**Town of Kittery
Planning Board Meeting
March 23, 2023**

ITEM 2 – 39 Badgers Island, Sketch Plan Review – Minor Cluster Subdivision

On behalf of BIW Group LLC – Owner and **Otter Creek Homes - Applicant** we submit herewith the attached package for **Final Subdivision Approval** at the March 23, 2023, Planning Board Meeting. In support thereof, we are submitting a revised Site Plan set with the associated revisions as needed to address the comments from CMA Engineers, along with this letter explaining the changes. The specific comments from the CMA letter are repeated below; with our response in **bold** text:

CONDOMINIUM SITE PLAN
39 BADGERS ISLAND WEST
CONDOMINIUM

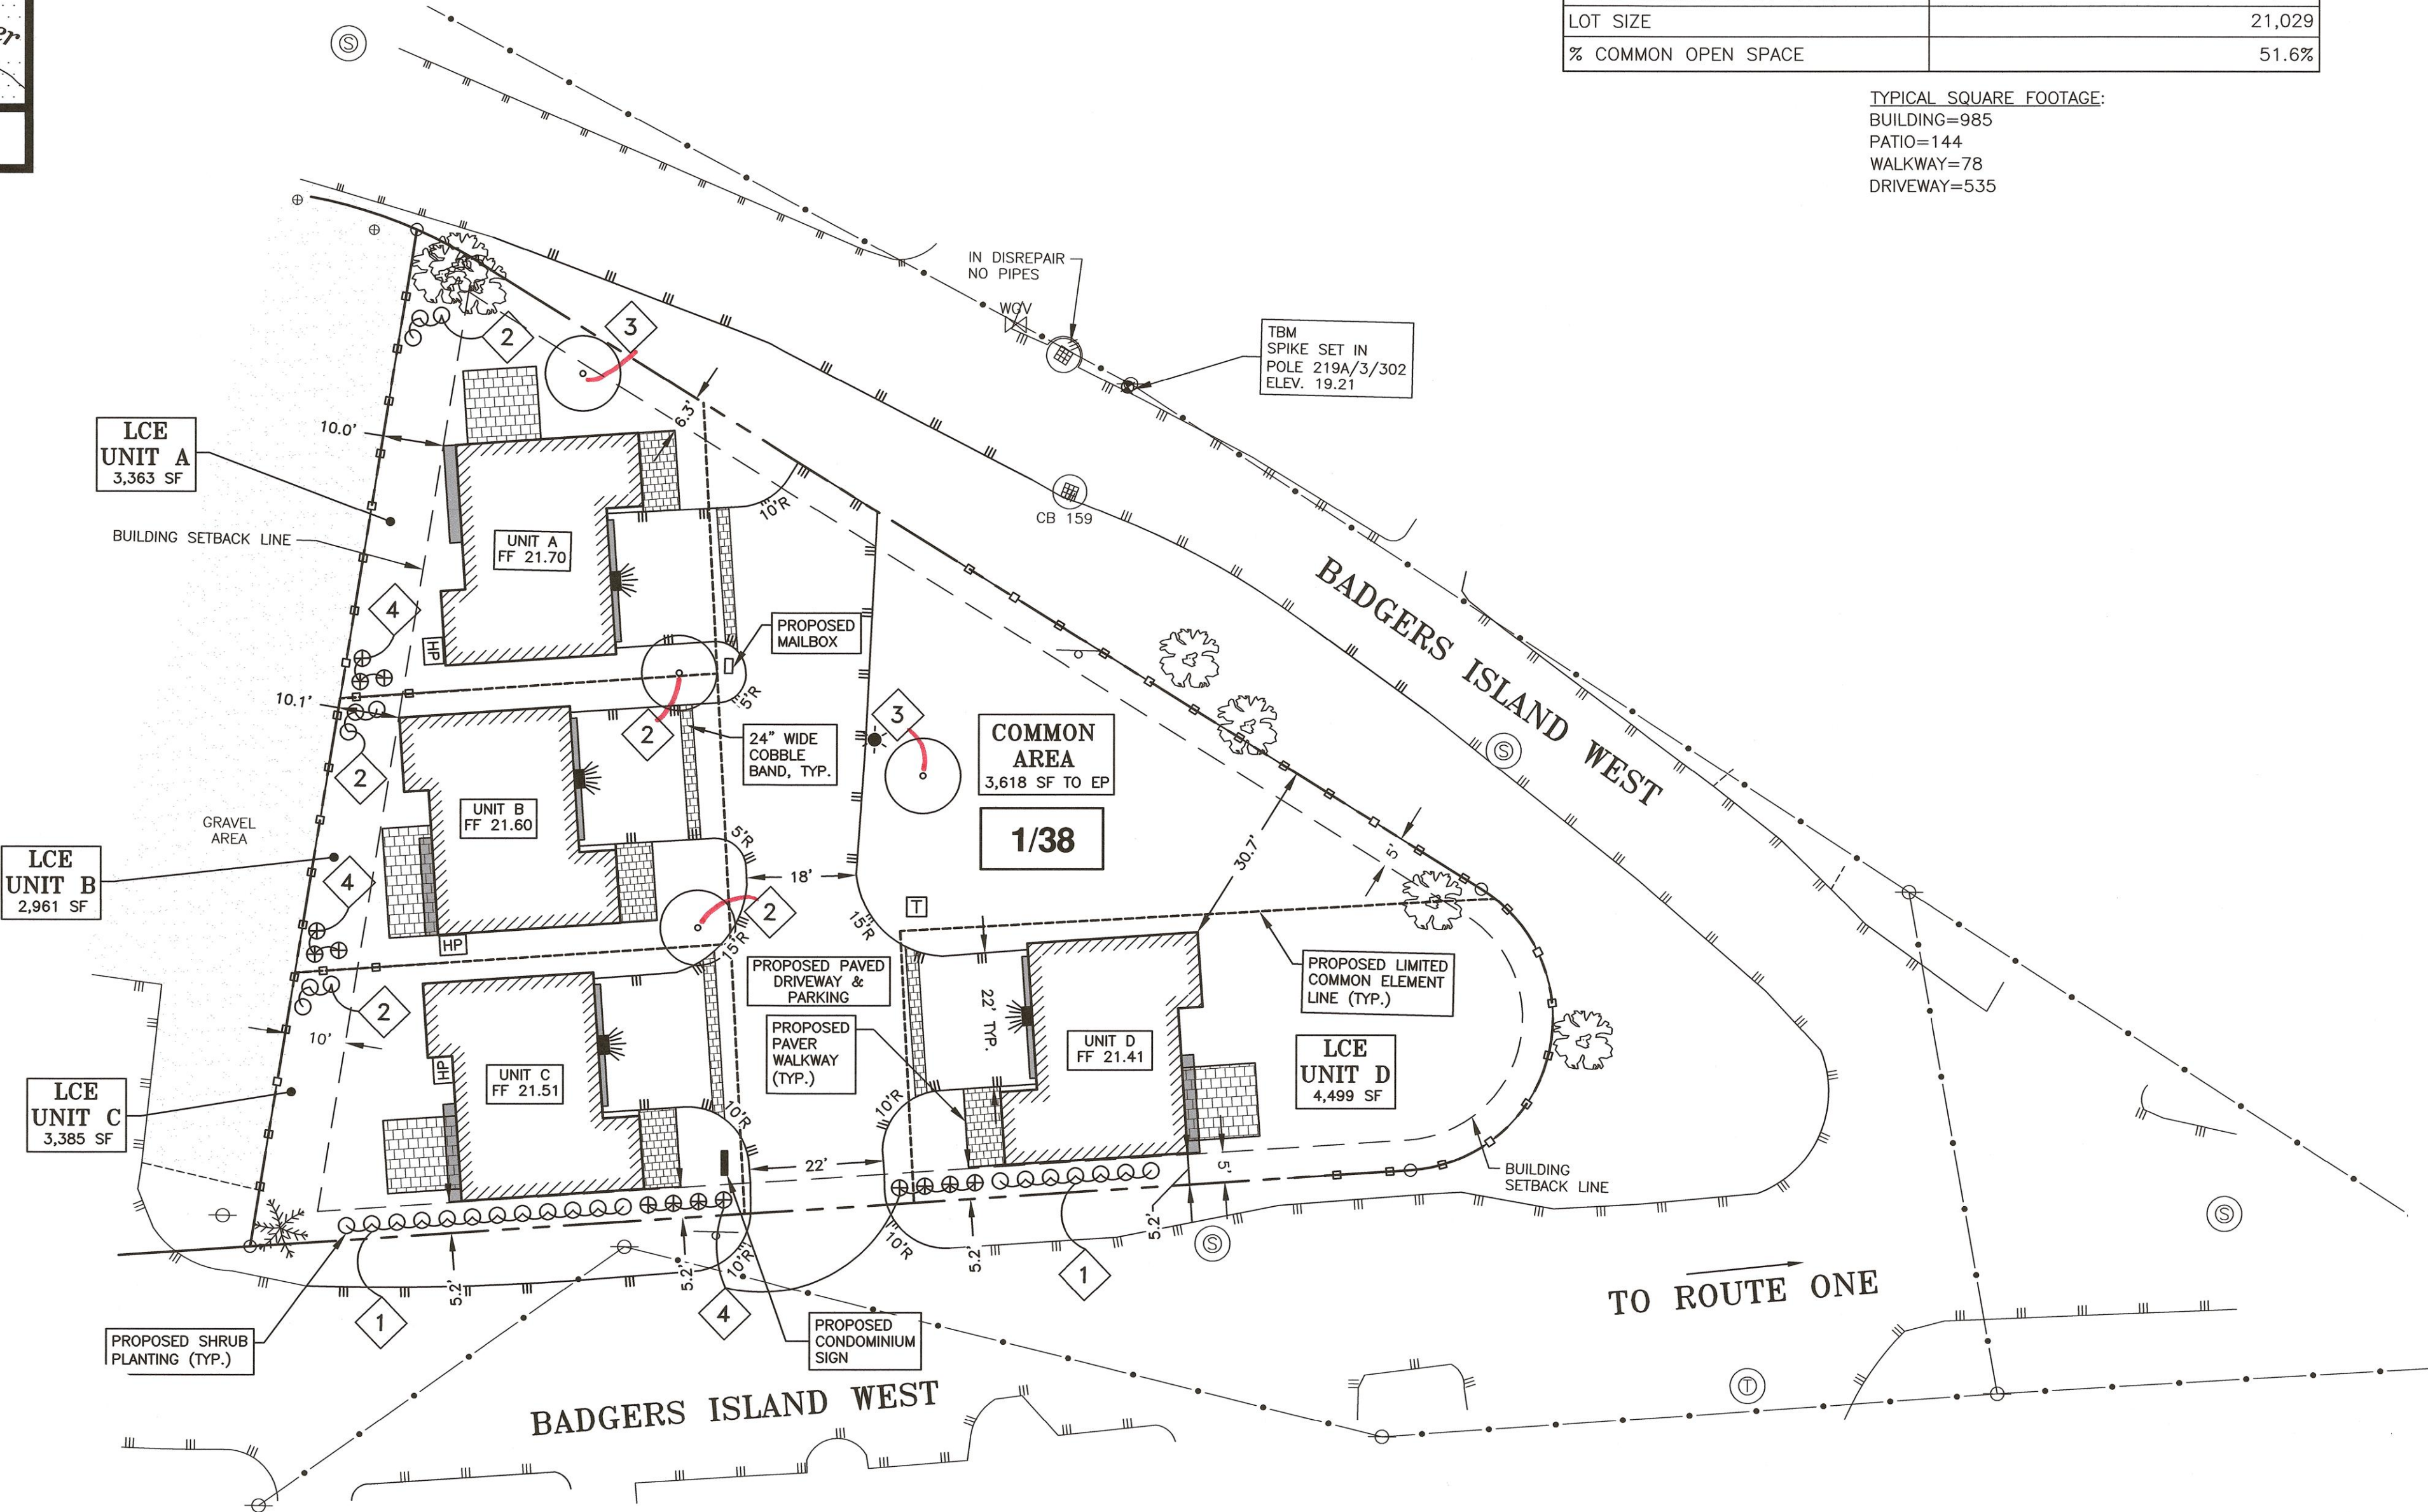
1. The legend should be updated to apply to the plan. **Completed.**
2. The certification items B and C do not appear to apply. **Certification removed.**
3. Note 8 should be amended to read Kittery Water District and Kittery Sewer Services. **Completed.**
4. There are undefined shaded and brick areas at each unit that should be called out. **See Legend.**
5. Note 9 references landscaping, should landscaping elements be defined/called out? **Completed, and Note 9 updated.**

EXISTING CONDITIONS
PLAN

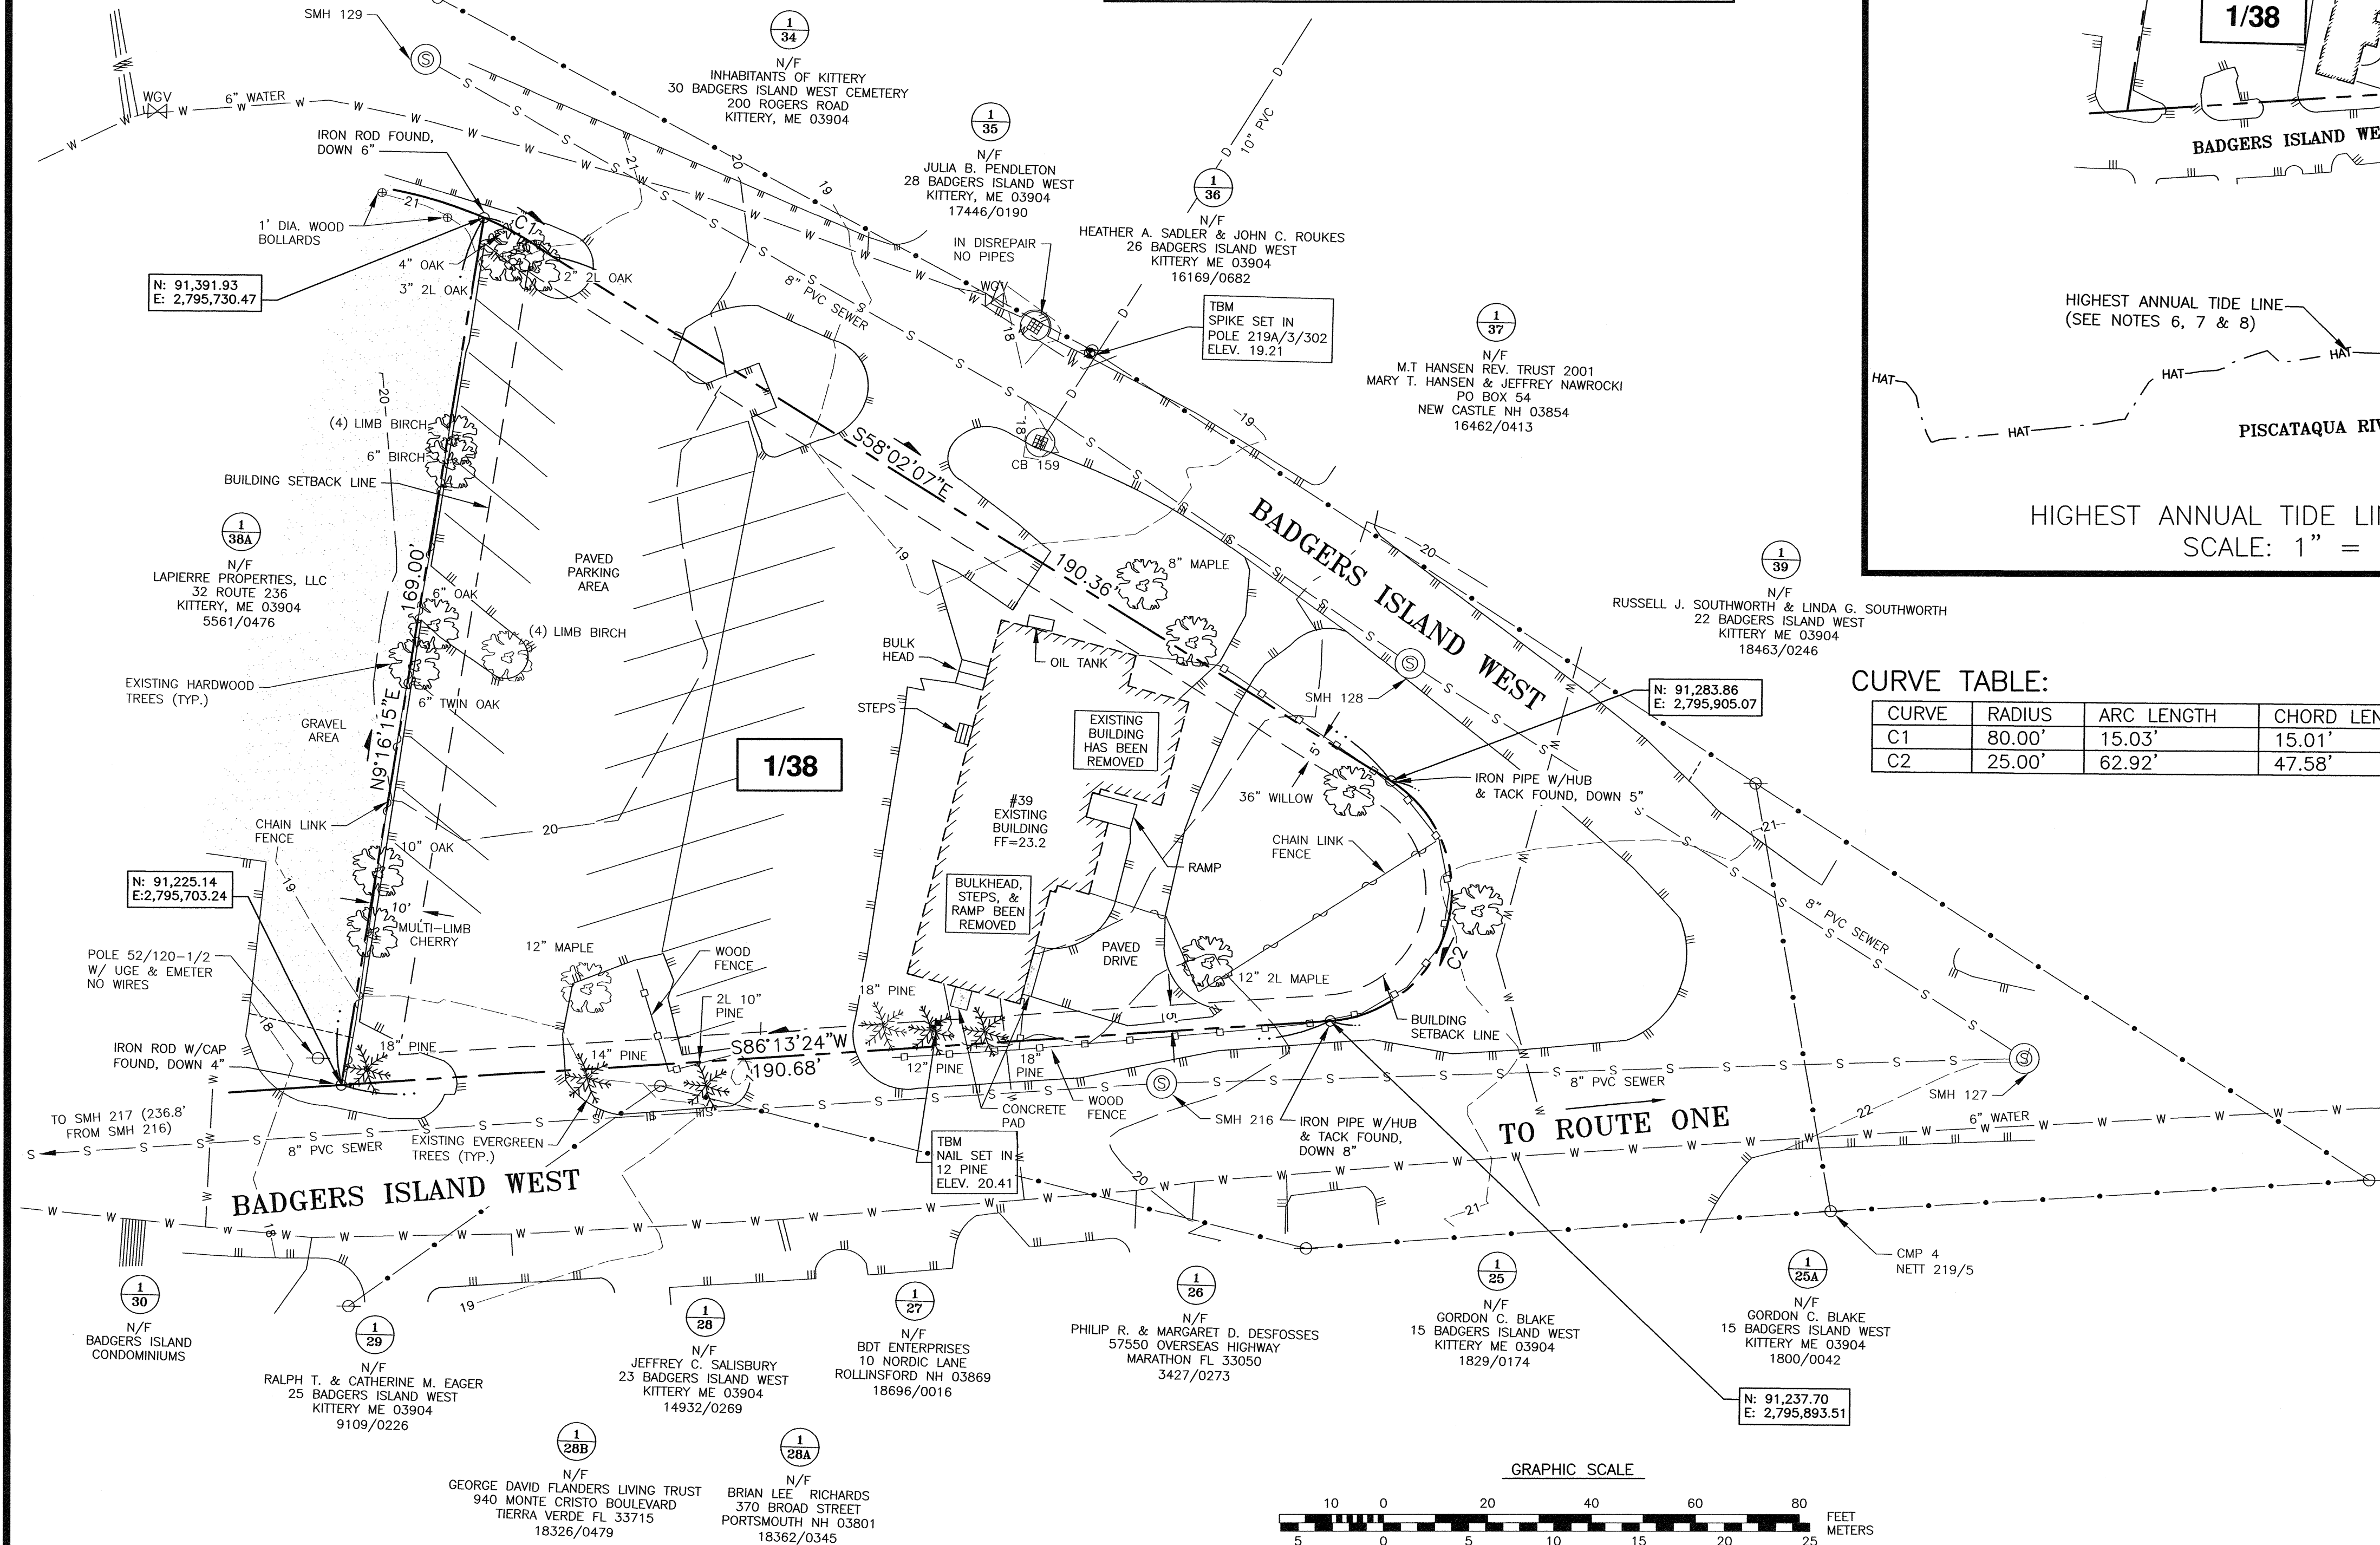
1. SMH 217 is not shown on the plan. It should be removed from the sewer structure table. **SMH 217 is out of view; however, it is important as it is in the sewer main run that the project will connect to, so we are leaving it in. We labelled the location (arrow and distance) to SMH 217 in the plan view.**

2. CB 159 should be labelled. **Completed.**
3. For the existing CB north of the project, disrepair is one word (no hyphen). **Completed.**
4. The sewer pipes materials, PVC, should be labeled next to the pipe size on the plan. **Completed.**

5. The water main material should be labelled on the plan. **We have labelled as much information as we have.**
6. Are the features steps, bulkhead, ramp, concrete pad, etc. still on the site or have they been removed? **Removed.**

7. If the existing building has been removed, should it be shown on the plan? **We prefer to leave the plan as shown, but we adjusted the lines to show it as removed.**

8. The concrete pad multileader at the south of the former building is only pointing to one pad. **Revised.**
9. The existing water service size and material should be shown. **We have labelled as much information as we have.**

10. The existing sewer service size, material and location should be shown. **We have labelled as much information as we have.**
11. Note 10 should include the dimensions provided in addition to the requirements. **The dimensions are shown on the proposed plan; see Sheet C2.**
